# Modification Recommended Service Note

## M9018B PXIe Chassis: 18 Slot, 3U, 8 GB/s

M9018B Soft Front Panel displays Unexpected Internal Software Error (BFFA0018)

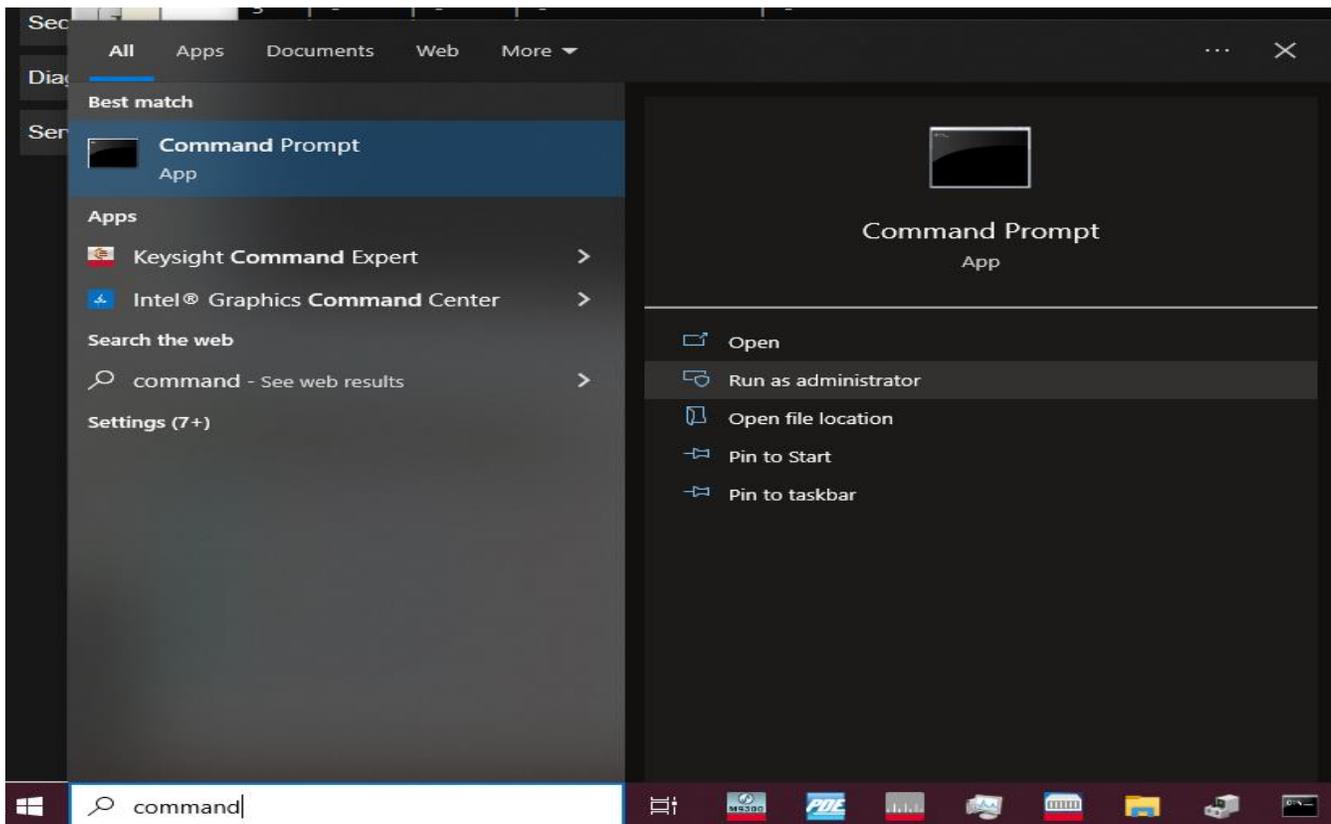
It has been found that when the Soft Front Panel for a PXle Chassis M9018B was opened, the following Soft Front Panel error was generated:

It was discovered that the trigger bridge of the firmware was displaying the incorrect User Code, which generated the above error and prevented the chassis SFP from being opened.

The user must program the left bridge trigger using the "lattice\_xsvf\_player" program tool. See the Syntax.txt file located in the zipped Lattice for how to run the tool. **Program the trigger bridge 2 times to ensure it is working properly.**
